6(A). Site Plan Amendment I Application – 107 Catamount Drive – Toxic Lolli LLC, Owner & Applicant. The Applicant is requesting Site Plan Amendment approval for a proposed 13,530 square foot per floor, 2-story Research & Development building addition and associated infrastructure. Also proposed is redesign of the parking area to accommodate the building addition and provide better internal circulation. The existing water service would remain; the existing on-site wastewater disposal system would be removed and the site would connect to the municipal sewer line. The site is located at 107 Catamount Drive and described as SPAN #11572, Tax Map 3, Parcel 8-7. The subject property contains a total of approximately 3.12 acres and is located within the "General Industrial" (I2) Zoning District and the Catamount Planning Area.

DEVELOPMENT REVIEW BOARD STAFF REPORT

Hearing Date: January 14, 2016	
Case No: DRB 2016-1	
Application(s): Site Plan Amendment I	
Application Received: November 10, 2015	
Application Deemed Complete: December 8, 2015	
Staff Report Finalized: January 11, 2016	
Applicant(s): Toxic Lolli, LLC c/o Jeffrey Jimmo 136 Jimmo Drive Colchester, VT 05446 jjimmo@osets.com 802-

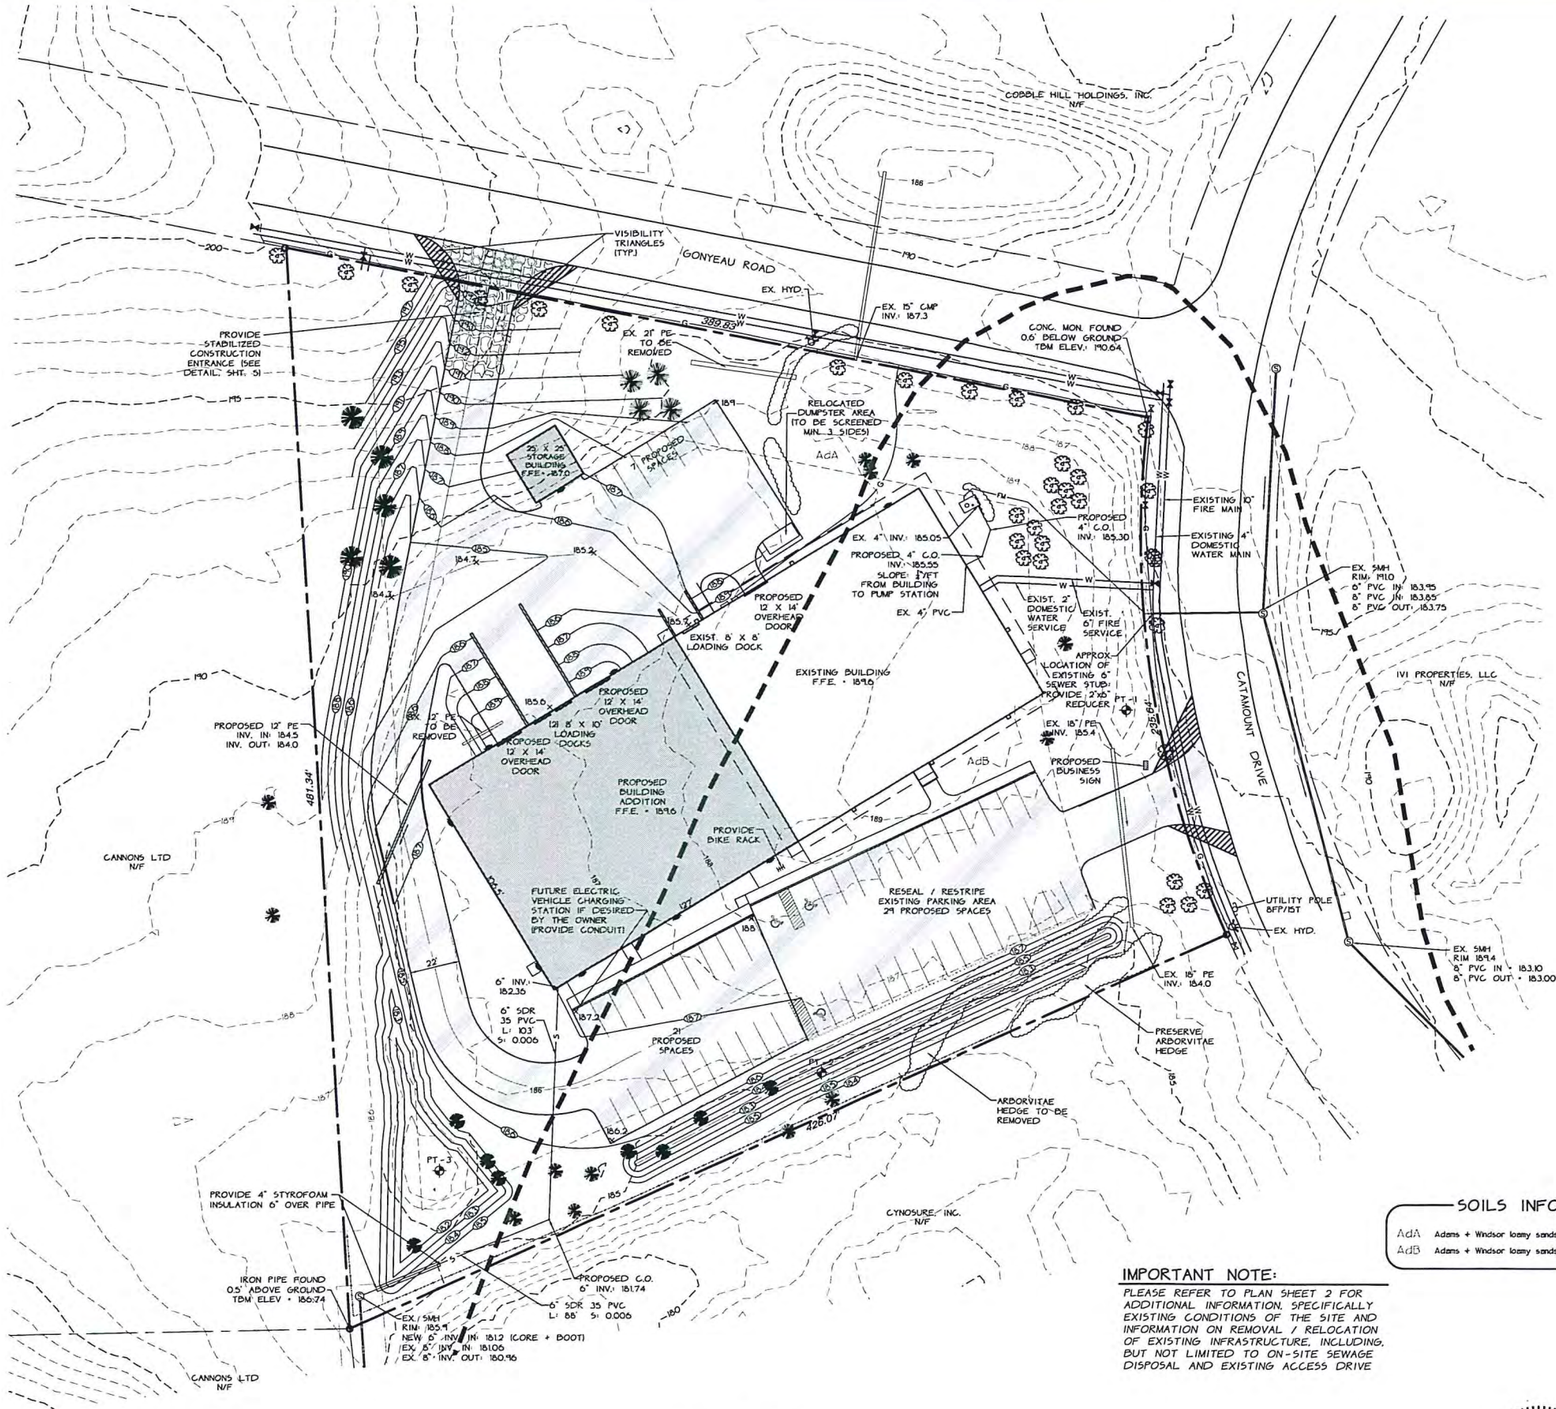
ZR590, Roads and Drives: The section states, "All roads and drives shall conform to the requirements of this Section. " A new highway access is proposed on Gonyeau Rd. Review by Public Works Director, Roger Hunt states the curve radius for the new access to Gonyeau Rd is not indicated in the plans.

1. The Final Plan shall indicate the curve radius for the new access to Gonyeau Rd.

9. The plan shall show the curve radius for the new access to Gonyeau Road

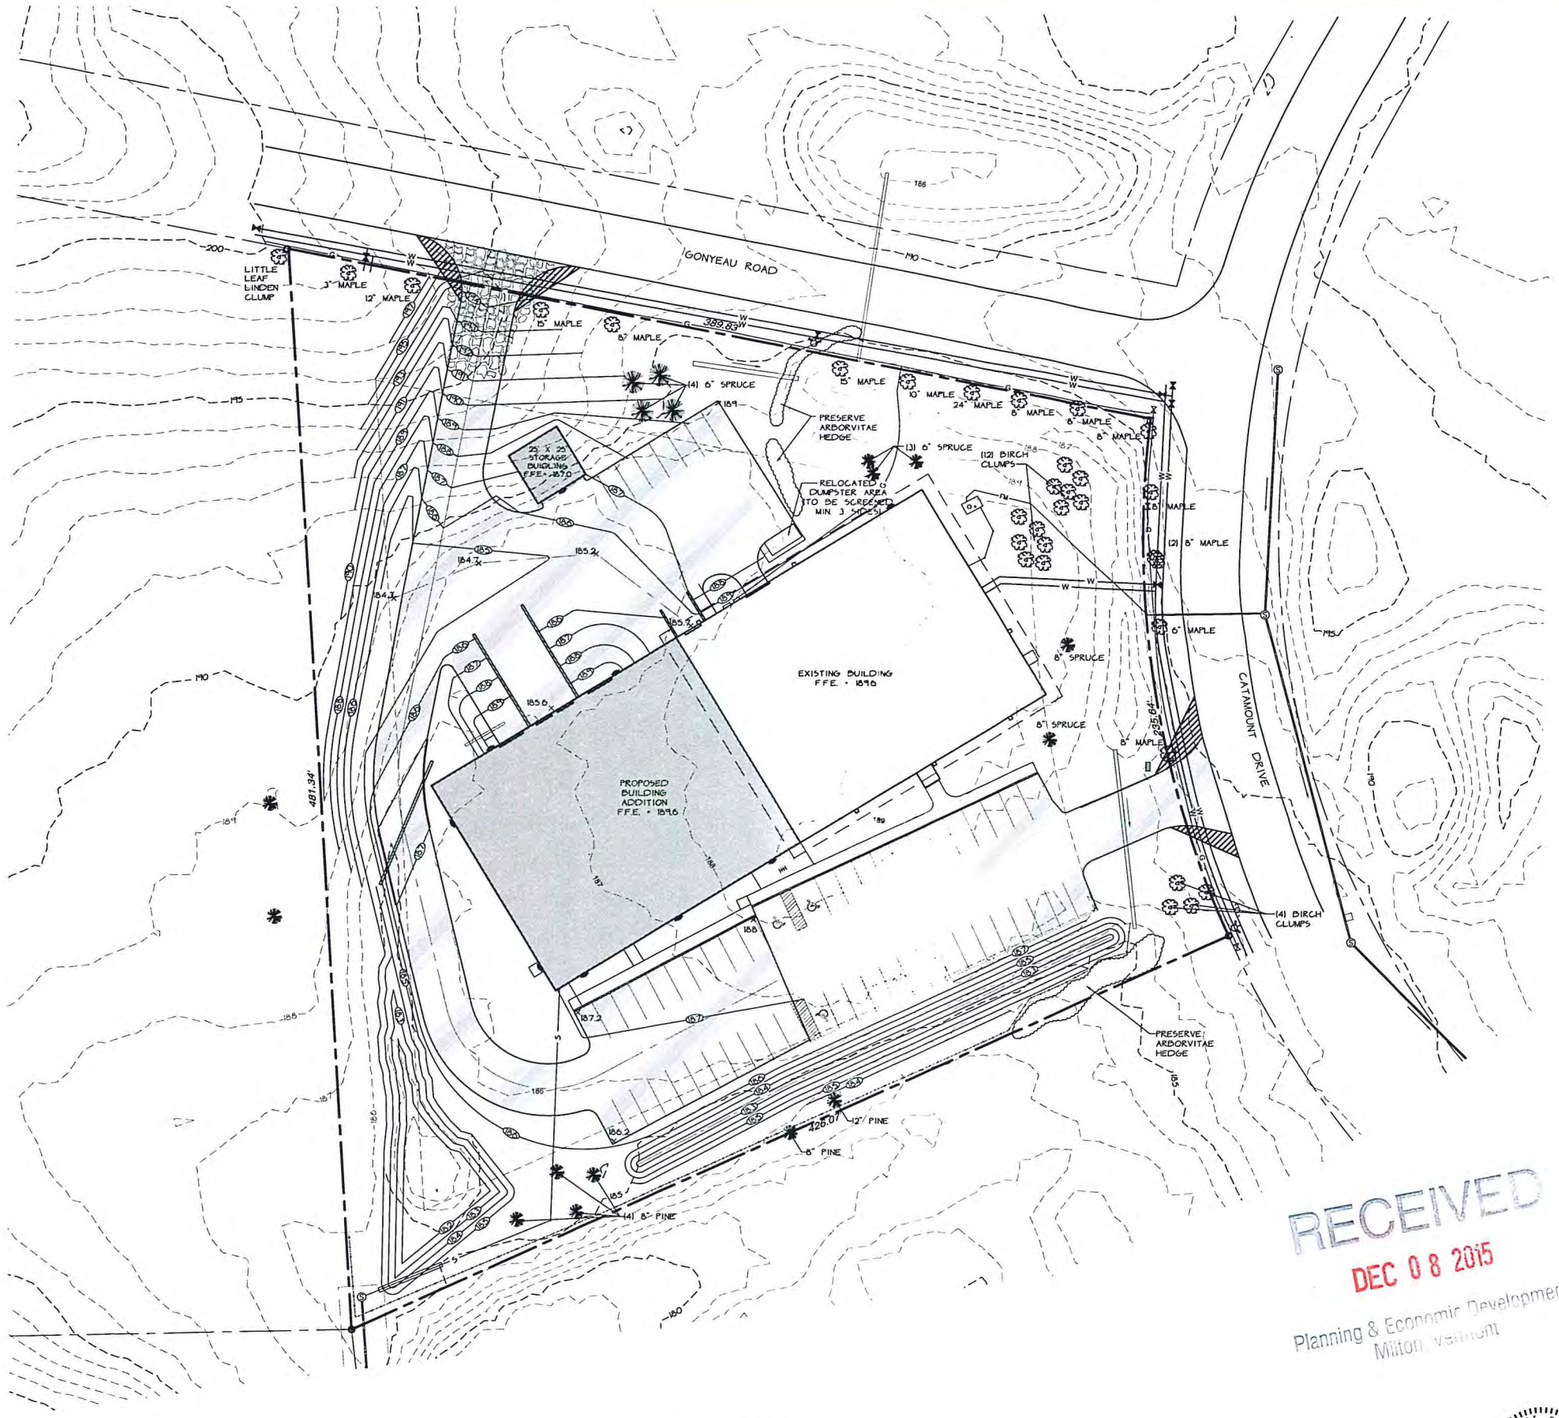
ZR806, Landscape Plan Requirements: The site currently contains mature landscaping installed according to the approved landscaping plan of 1998. The applicant estimates the existing and proposed improvements to be valued at $2.5 million and the value of the existing mature landscaping to be $67,100. According to ZR806.4, the minimum planting cost for this site should equal 1% of the total land development cost. ZR806.5 states that some credit may be granted for existing trees...as long as the objectives of this section are not reduced.

12. Remove arborvitaes within the Right Of Way adjacent to Fire Hydrant #AA-20 on Gonyeau Road.
